/
	•	Application	on No.	Applicant(s)	01
Office Action Summers		09/921,84	· ·	MICHELSON, GA	RY K.
	Office Action Summary	Examiner		Art Unit	
		Bruce E S		3738	
Period 1	— The MAILING DATE of this communication or Reply	appears on the	e cover sheet with	n the correspondence ad	dress -
THE - ext atta - ff ff - ff And - And - And	HORTENED STATUTORY PERIOD FOR REMAILING DATE OF THIS COMMUNICATION on since of time may be available under the provisions of 37 CF of SIX (8) MONTHS from the mailing date of this communication of period for reply specified above is less than thirty (30) days, to Operiod for reply is specified above, the maximum statutory of the period within the set or extended period for reply will, by some period by the Office later than three months after the need patent term adjustment. See 37 CFR 1.704(b).	DN. FR 1.136(a). In no evi n. a reply within the stat eriod will apply and within the cause	ent, however, may a rep untory minimum of thirty ill expire SIX (6) MONTI fication to become ABA	oly be timely filed (30) days will be considered timel Hi3 from the malling date of this c NOONED (35 U.S.C. § 133).	y. ommunicátion.

DETAILED ACTION

In re Application of:) Confirma

Species 3 (elected embodiement)

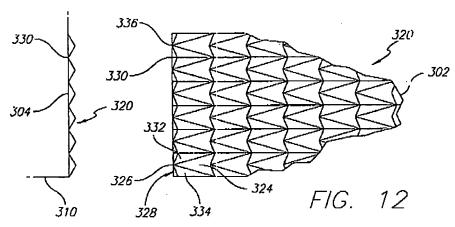
Regarding claim 131, the elected embodiment shown in figures 12-15 has left and right facets that are identical, the left facet is not steeper than the right facet.

The Examiner noted that in contrast to the subject matter of claim 131, the elected species of Figs. 12-15 showed left and right facets that were identical. (Office Action, page 2, second paragraph). An exemplary embodiment of claim 131 is illustrated in Fig. 12B, which was added in response to the Examiner's request in the Office Action dated April 23, 2003 ("the April Office Action"). In particular, Fig. 12B shows a right facet having a longer length than a left facet, the left facet having a steeper slope than the right facet. (See Exhibit A, Fig. 12B, annotated for the Examiner's convenience). Although Fig. 12B may look similar to Fig. 12A, each figure is different because the facet configuration is oriented in a different direction. In Fig.

12A, the facet having a longer length (facet 324) is oriented toward leading end 302. In Fig. 12B, the facet having the longer length is oriented toward s de 310'.
